GFA AD 468
(ISSUE 1)

GFA AIRWORTHINESS DIRECTIVE

TYPE AFFECTED: DG-400.

SUBJECT: Replacement of the regulator.

Z 33 Conversion kit Saprisa regulatorInstallation instructions

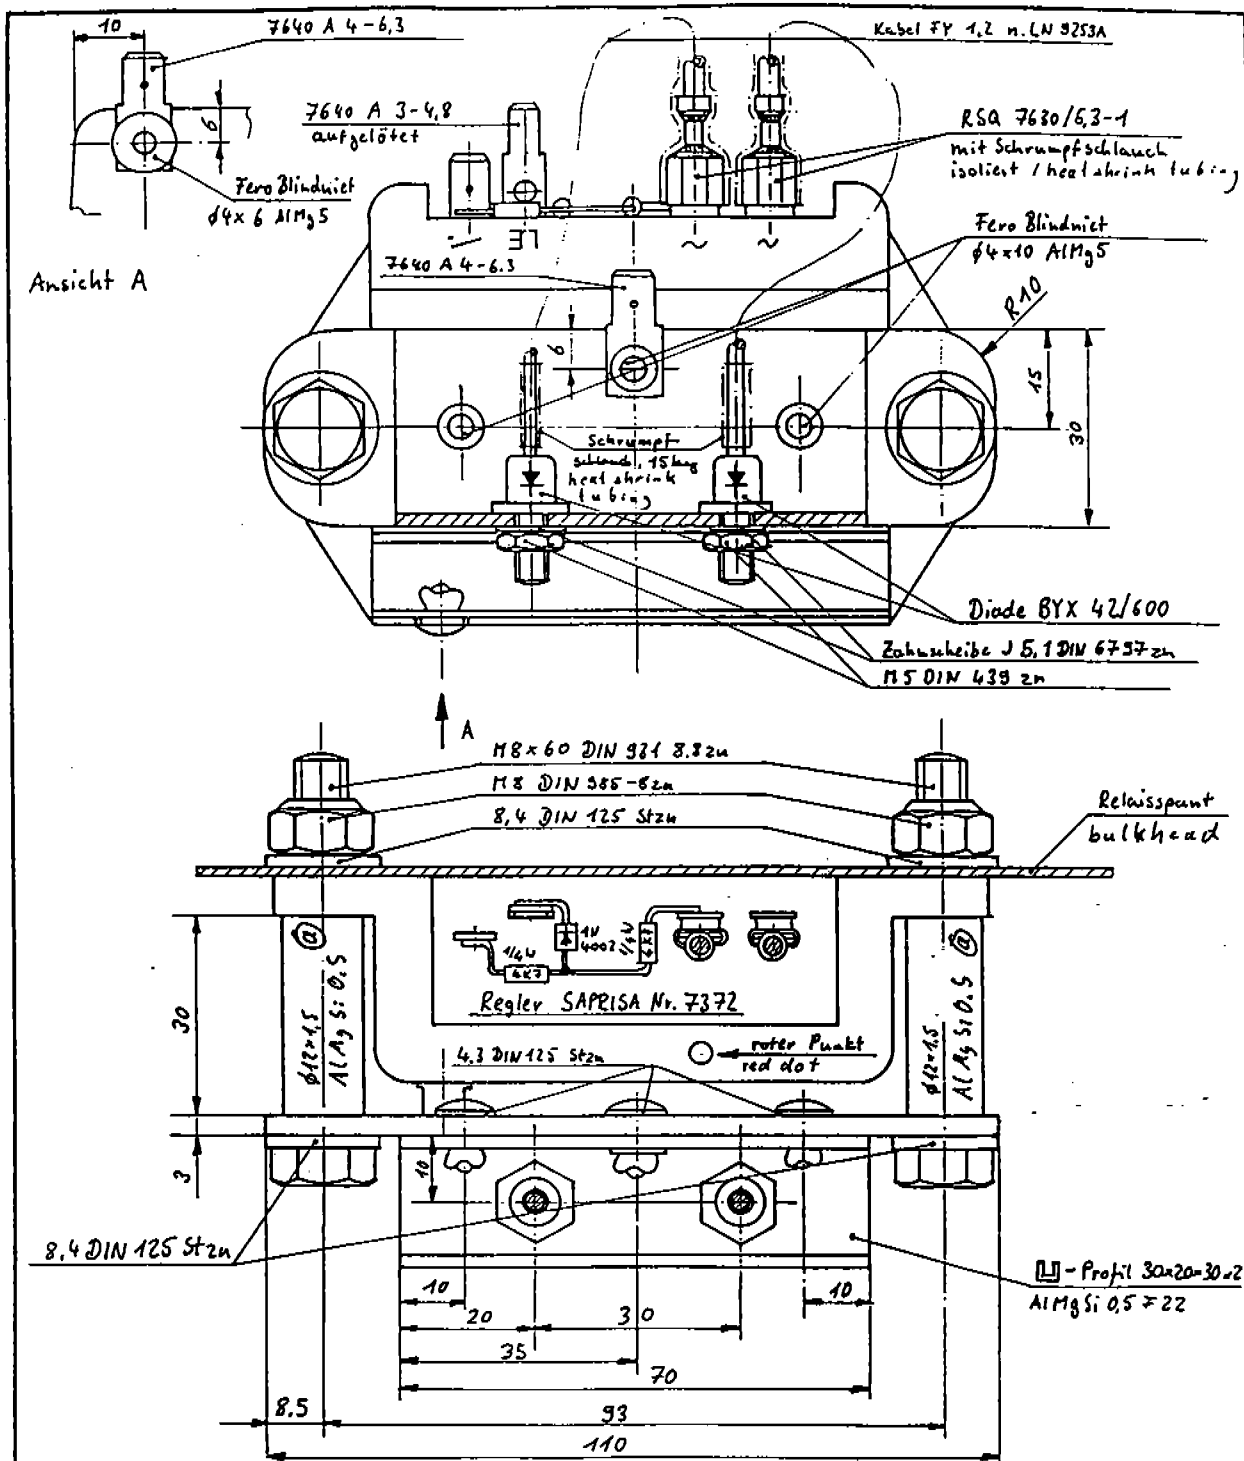
- Instructions: 1. Installation of the modified regulator 4 E 26.
To fix the regulator 2 new holes dia. 8 mm must be drilled to the bulkhead (see sketch below).
Plug the wires to the new regulator.
The wires are marked with the numbers according to the scheme below.

1 regulator 4 E 26	
2 tubes	12 x 1.5 x 30
2 bolts	M 8 x 60 DIN 931 - 8.8 zn
2 washers	8.4 DIN 125 Stzn
2 self locking nuts	M 8 DIN 985 - 8 zn
drawing 4 E 26
